M^CLAREN TRAFFIC ENGINEERING

25 June 2026

Reference: 250737.03FA

LETTER OF RESPONSE TO DPHI, TWEED SHIRE COUNCIL AND TFNSW REGARDING THE PROPOSED MIXED USE DEVELOPMENT AT 4-8 BELLS BOULEVARD, KINGSCLIFF

FIGURE 2: DRIVEWAY SIGHTLINE ASSESSMENT – FOR 85TH PERCENTILE SPEED

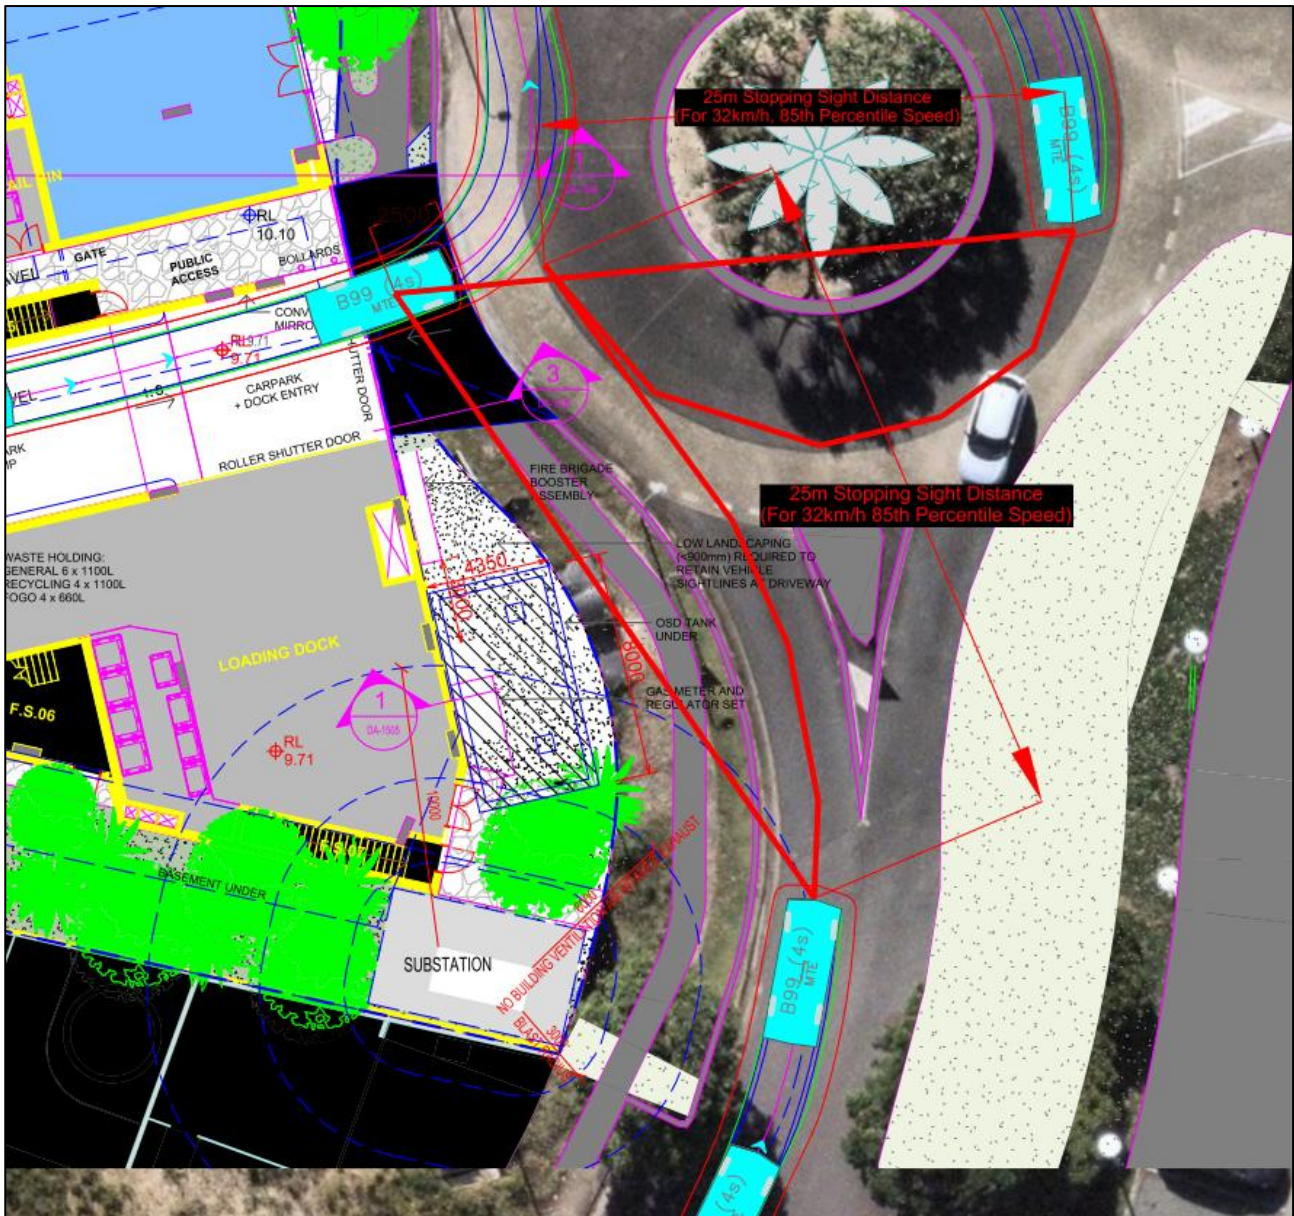
4	<i>There is no pedestrian crossing provision for pedestrians at the existing roundabout or proposed as part of the works.</i> <i>This may result in pedestrians crossing the road at inappropriate locations.</i>	Medium	A pedestrian crossing point already exists 30m north of Gunnamatta Ave/Site Driveway roundabout, as shown in the image below, providing a pedestrian crossing point in-line with expected pedestrian desire lines (to/from beach/park). Vehicle speeds within the proximity of the roundabout are low. 
5	<i>From the plans, it appears that the roundabout dimensions are being changes (n.b. an overlay of the layout plan on a nearmap suggest that approaches/exits on the eastern side are being widened significantly (possible enough for an additional lane) which would be likely to result in less deflection and excess speed with a resulting increase in the severity of any crashes.</i>	High	No changes are proposed to the roundabout on Gunnamatta Road. The identified widening is a drafting error, and the amended plans have been updated to ensure the plans match the geometry of the existing roundabout. No additional circulating or approach lanes are proposed.

As outlined above, the project manager and team have addressed the identified risks as best as practicable and concludes that the risks associated with the subject design remain low, given the low speed environment, low frequency of loading dock utilisation and design features included (such as convex mirrors, signage and compliant sightlines) with the intention of further reducing the risk associated with the subject driveway design. The driveway design has been developed with consideration to the range of site constraints, particularly around activation of the site frontage and provision of loading facilities as far away as possible from the active frontages of the subject site.

3 SECTION_CARPARK RAMP
DA-1002 SCALE 1:100

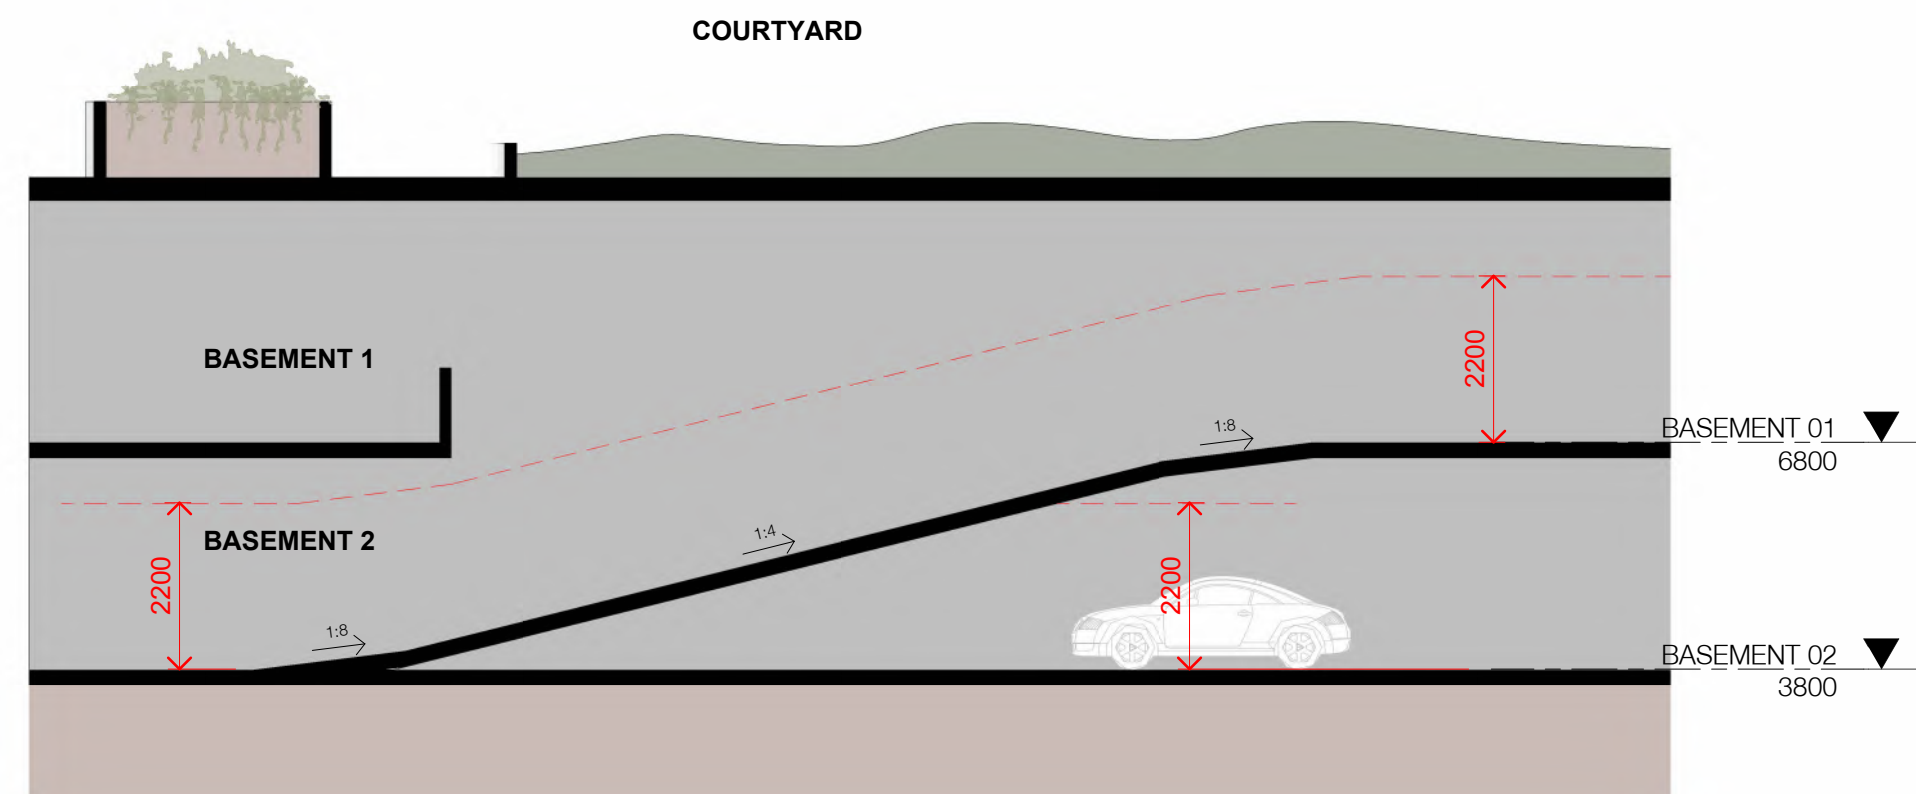
It is unclear if there is adequate headroom available or residential carparks that are located underneath the basement carparking access ramp. The section diagrams nor the Traffic Impact Assessment provide detail on this headroom and it is recommended that this be provided.

MTE Response: A minimum headroom of 2.2m is provided for the relevant residential car parking spaces provided under the access ramp. Sections of the ramp indicating the available headroom is provided in **Annexure A** for reference and confirmation.

Figure 1: Proposed Site Access Location

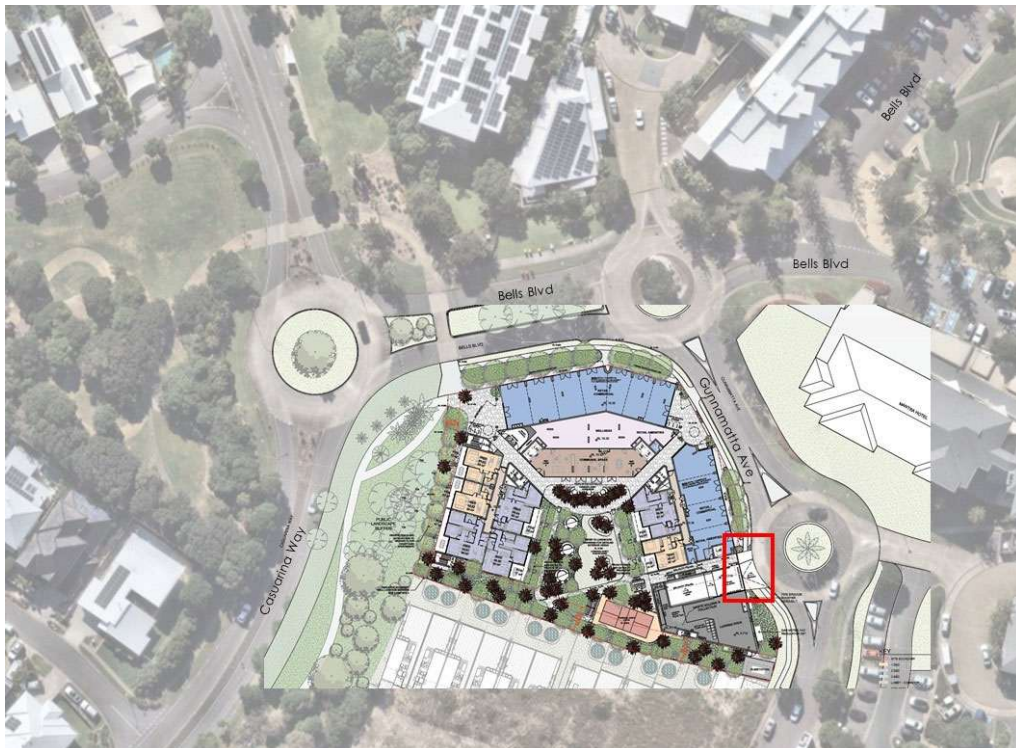
The current position and configuration of the driveway present potential road safety risks. The safe operation of a roundabout relies on adequate sight lines, and both the adjacent building structure and driveway grades significantly restrict visibility. The driveway is also partially concealed, making its location less intuitive for approaching drivers. The requirement for waste collection vehicles to negotiate movements with exiting traffic further increases the likelihood of vehicle movement conflict.

Table 4.2: Road Safety Audit Findings

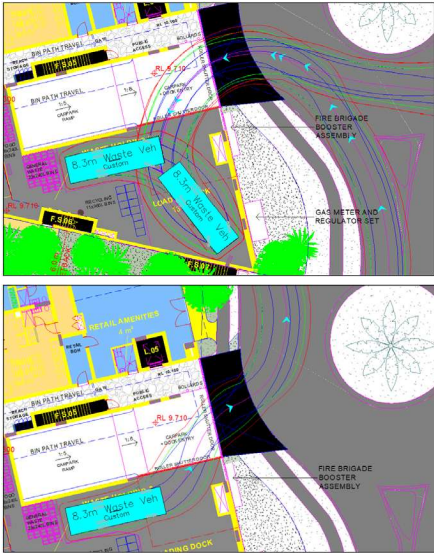
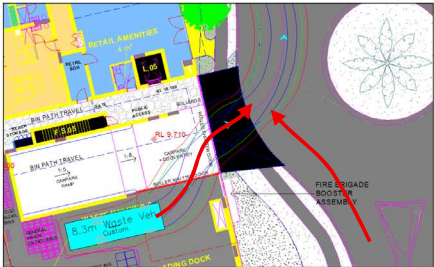
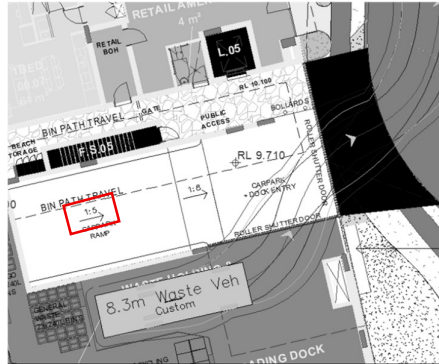
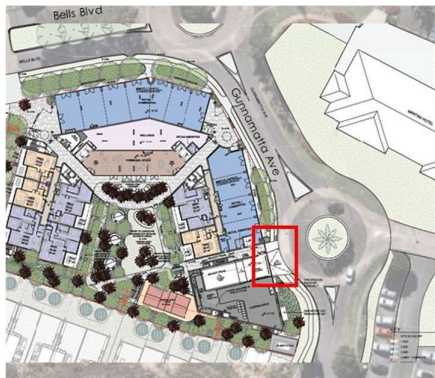
Item No.	Location	Descriptions of Findings	Design/ Photo	Likelihood	Severity	Risk Rating	Recommendation
1	Site access	The swept paths indicate that a waste collection vehicle would occupy the full width of the driveway when entering or leaving the site. However, it is acknowledged that AS2890.2:2018 Section 3.2.2 states that if the usage of the loading dock is classified as Occasional Service, the full width of the access driveway may be used for both entering and leaving the site.		-	-	Note only	N/A
2	Site access	Given the proximity of the loading dock to the site access, a waste collection vehicle would have to make an "S-curve" manoeuvre when leaving the site from the loading dock. The building structure may impede the mutual sight distance for the truck driver and a motorist entering the site. A motorist entering the site from the south may not be aware that a waste collection vehicle is leaving the loading dock at the same time.		Possible	Minor	Medium	Designer to confirm roundabout sight distance criterion can be satisfied in accordance with Austroads GTRD Part 4B for vehicles leaving the site.

Item No.	Location	Descriptions of Findings	Design/ Photo	Likelihood	Severity	Risk Rating	Recommendation
		This would increase the likelihood of traffic conflicts at the driveway. In addition, sudden braking to avoid a collision with the waste collection vehicle may result in a rear-end potential on the circulating lane at the roundabout.					
3	Site access	An exiting passenger car would have to stop on the ramp that has a 1:5 grade when a waste collection vehicle is leaving the loading dock. A 1:5 grade is too steep for a vehicle to stop safely. A vehicle may roll back on the slope resulting in possible rear-end conflicts. AS2890.1 stipulates a maximum grade of 1:10 for a queuing area for not less than 0.8 of the queue length determined in Table 3.3.		Possible	Property damage	Low	Provide a queueing area with a maximum grade of 1:10 to be compliant to AS2890.1.
4	Site access roundabout	There is no pedestrian crossing provision for pedestrians at the existing roundabout or proposed as part of the works. This may result in pedestrians crossing the road at inappropriate locations.		Possible	Minor	Medium	Consider the provision of a pedestrian crossing facility at the roundabout

Item No.	Location	Descriptions of Findings	Design/ Photo	Likelihood	Severity	Risk Rating	Recommendation
5	Site access roundabout	From the plans, it appears that the roundabout dimensions are being changed (n.b. an overlay of the layout plan on a nearmap suggests that the approaches/exits on the eastern side are being widened significantly (possibly enough for an additional lane) which would be likely to result in less deflection and excess speed with a resulting increase in the severity of any crashes.	 	Possible	Moderate	High	Ensure that scope of scheme is correctly shown on drawings such that it doesn't affect the eastern side of the roundabout. If it does widen the roundabout on the eastern side, there is a need to prepare plans showing line markings etc which should be included in this audit.

Item	Finding	Risk Rating	Project Response
1	<i>The swept paths indicate that a waste collection vehicle would occupy the full width of the driveway when entering or leaving the site.</i> <i>However, it is acknowledged that AS2890.2:2018 Section 3.2.2 states that if usage of the loading dock is classified as Occasional Service, the full width of the access driveway may be used for both entering and leaving the site.</i>	Note only	This is correct. The waste collection vehicle is occasional service as per the definition in AS2890.2:2018 and hence the full width of the driveway may be used.
2	Given the proximity of the loading dock to the site access, a waste collection vehicle would have to make an "S-curve" manoeuvre when leaving the site from the loading dock. The building structure may impede the mutual sight distance for the truck driver and a motorist entering the site. A motorist entering the site from the south may not be aware that a waste collection vehicle is leaving the loading dock at the same time. This would increase the likelihood of traffic conflicts at the driveway. In addition, sudden breaking to avoid a collision with the waste collection vehicle may result in a rear end-potential on the circulating lane at the roundabout.	Medium	The location and design of the loading dock is driven by various site constraints and a desire to ensure active frontage is provided along the primary frontage of the site. The proposed plans propose an 2m "visibility screen" at the edge of the loading dock and driveway that provides visibility from the loading dock to vehicles on the roundabout, and when exiting the loading dock, as shown in the below image.  An assessment of the Stopping Sight Distance has been undertaken, with the measured 85th percentile approach speed (from Compass IOT) from the south 32km/h (average speed 23.9km/h). This results in a 25m SSD distance, which is achieved, and shown above in Figure 2 of this letter. Speeds are low in and around the roundabout and the risk of the possible outcome identified is considered low.

Item	Finding	Risk Rating	Project Response
3	<i>An exiting passenger car would have to stop on the ramp that has a 1:5 grade when a waste collection vehicle is leaving the dock.</i> <i>A 1:5 grade is too steep for a vehicle to stop safely. A vehicle may roll back on the slope resulting in possible rear-end conflicts.</i> <i>AS2890.1 stipulates a maximum grade of 1:10 for a queuing area for not less than 0.8 of the queue length determined in Table 3.3</i>	Low	Usage of the loading bay will be infrequent, and waste collection occurs less than once per day. The likelihood of a service vehicle and light vehicle existing the loading area simultaneously is low. A convex mirror is proposed at the top of the ramp to assist service vehicle drivers identify any approaching drivers before exiting. A Loading Dock Plan of Management will outline that exiting vehicles need to give-way to vehicles exiting the basement car park. Further a notice or sign on the wall should be provided indicating "Give Way to Traffic", supported with linemarking.
